World Forum for Harmonization of Vehicle Regulations**Working Party on Automated/Autonomous and Connected Vehicles****Eighteenth session**

Geneva, 22-26 January 2024

Advanced Driver Assistance Systems and UN Regulation No. 79:**Advanced Driver Assistance Systems****Proposal for a supplement to the 03 and 04 series of amendments to UN Regulation No. 79 (Steering equipment)****Submitted by the experts from Germany, France, Netherlands, United Kingdom of Great Britain and Northern Ireland, and the European Commission***

Model A
(See paragraph 4.4. of this Regulation)

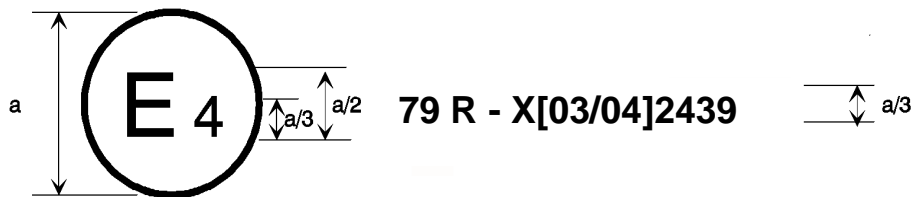
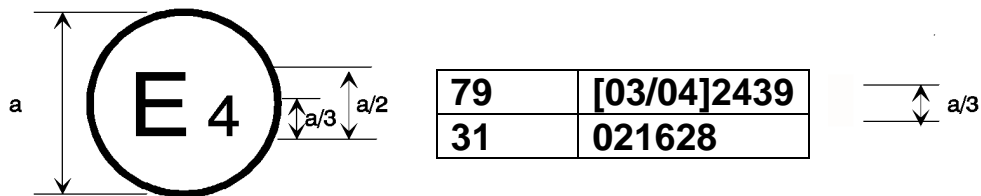
Annex 2, amend to read:

The above approval mark affixed to a vehicle shows that the vehicle type concerned has, with regard to steering equipment, been approved in the Netherlands (E 4) pursuant to UN Regulation No. 79 under approval No. [03/04]2439. The letter “X” preceding the approval number indicates that the vehicle is equipped with ACSF which has been exempted from the requirements of this UN Regulation, and/or that the vehicle is equipped with a steering system which exhibits functionality defined as an ACSF of Category B2, D or E. The approval number indicates that the approval was granted in accordance with the requirements of UN Regulation No. 79 incorporating the [03/04] series of amendments.”

Model B
(See paragraph 4.5. of this Regulation)

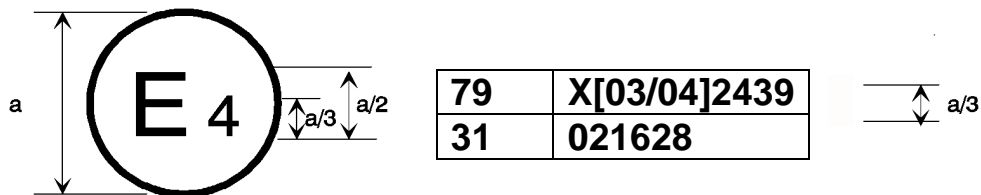
The above approval mark affixed to a vehicle shows that the vehicle type concerned has been approved in the Netherlands (E 4) pursuant to Regulations Nos. 79 and 31.^d The letter “X” preceding the approval number pursuant to Regulation No. 79

indicates that the vehicle is equipped with ACSF which have been exempted from the requirements of this UN Regulation, or that the vehicle is equipped with a steering system which exhibits functionality defined as an ACSF of Category B2, D or E. The approval numbers indicate that, at the dates when the respective approvals were given, UN Regulation No. 79 incorporating the [03/04] series of amendments and UN Regulation No. 31 included the 02 series of amendments.”
